## Technical Service Bulletin – Incorrect Thermal Overload Installed & Power Cord Requirements

*Twister T2E Trimming Machine Electrical Overload, Supply Power Cord Updates and Extension Cord Use Reminders for 220-240V / 50Hz Markets*

April 14, 2026

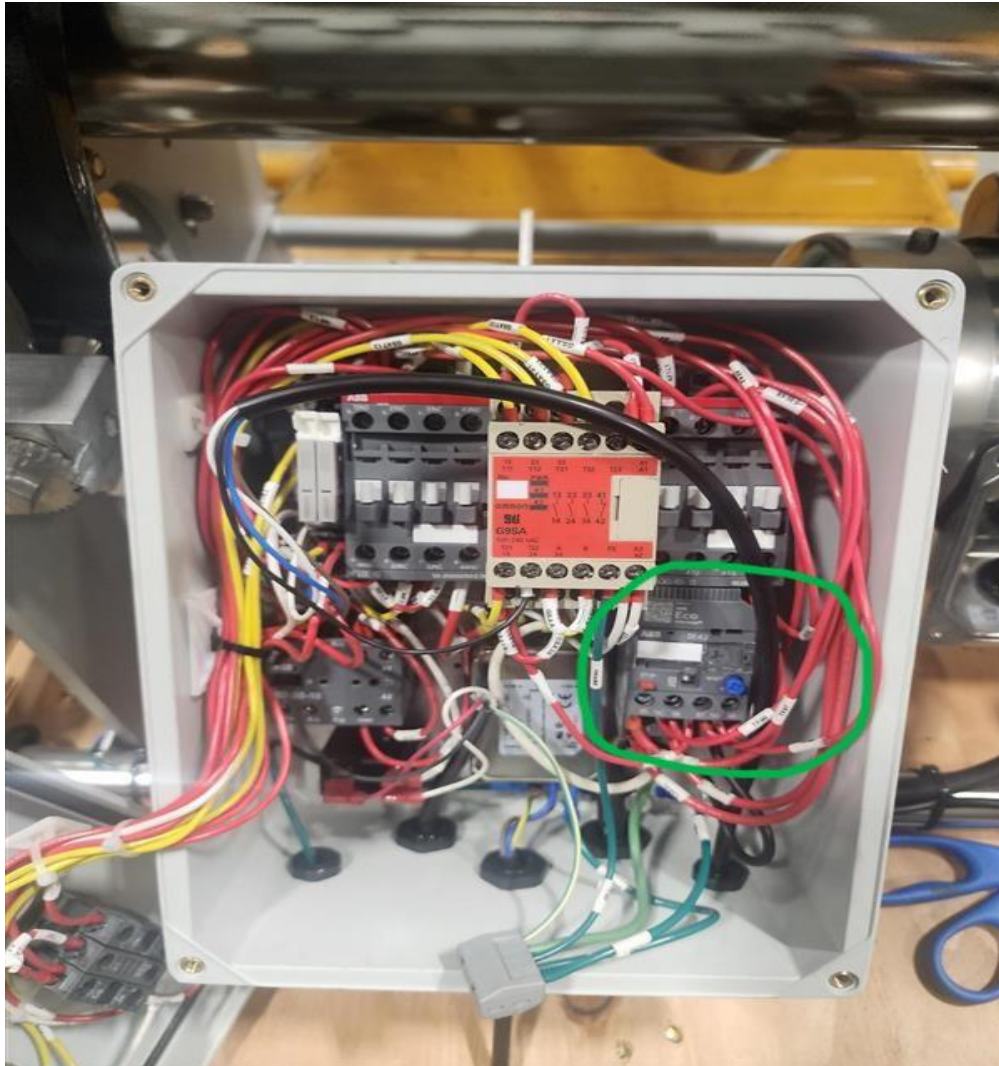
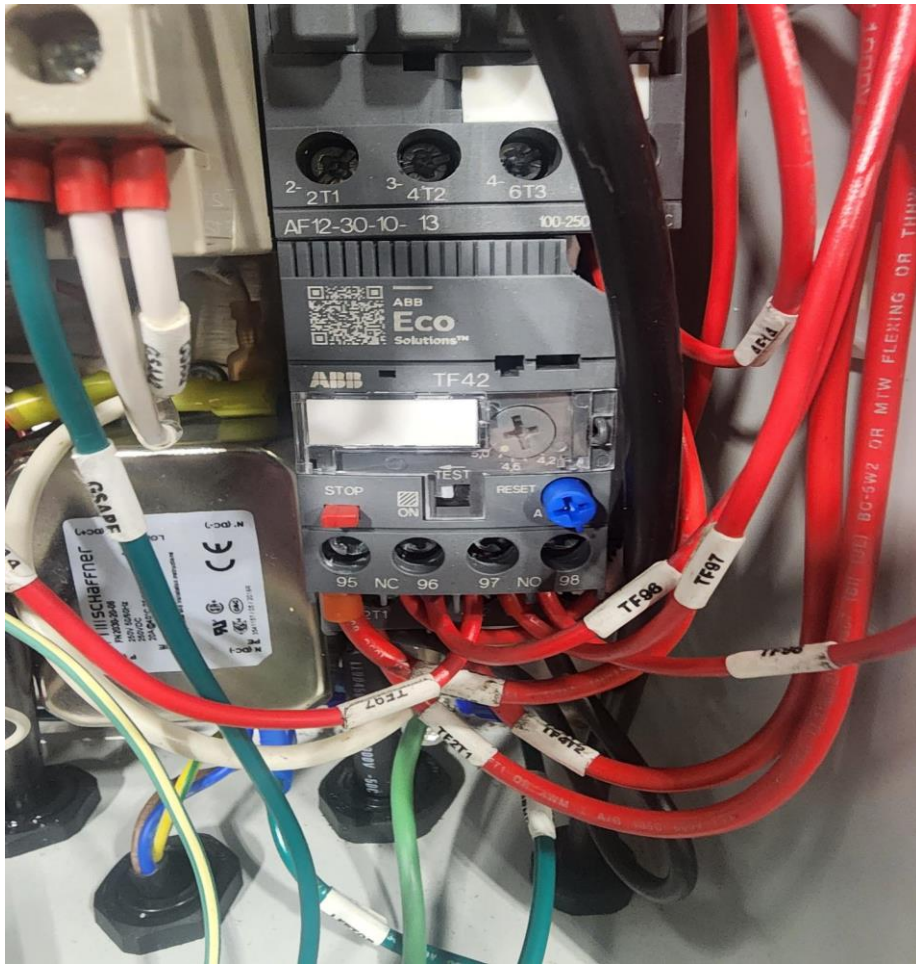
This technical service bulletin applies to certain Twister T2E Trimming machine operating in **220-240V / 50Hz** markets, including Europe, Australia, and New Zealand. Keirton has identified that some machines may have been fitted with an overload configuration that is rated too high for the intended electrical environment. This may allow the blade motor circuit to draw higher current than intended, increasing the likelihood of motor shutdown issues, failures, and capacitor damage. In addition, these same machines may have been fitted with thin gauge power supply cords, 1mm<sup>2</sup> (18 AWG), vs the required 3.3mm<sup>2</sup> (12 AWG)

Testing to date indicates that updating the overload to the revised specification, together with use of the correct approved power cord and supply setup, is expected to materially reduce recurrence. To make this process as simple as possible, customers only need to provide the machine serial number and a photo of the currently installed overload to request a replacement.

<b>Correct Overload Part#</b>	<b>15-10968</b>
<b>Required Amperage Setting</b>	4.8A
<b>Correct Power Supply Cable Assembly</b>	<b>27-10702</b>
<b>Approved Extension Cord Spec</b>	<b>3.3mm<sup>2</sup> (12 AWG) minimum, 7.6m (25') maximum length</b>
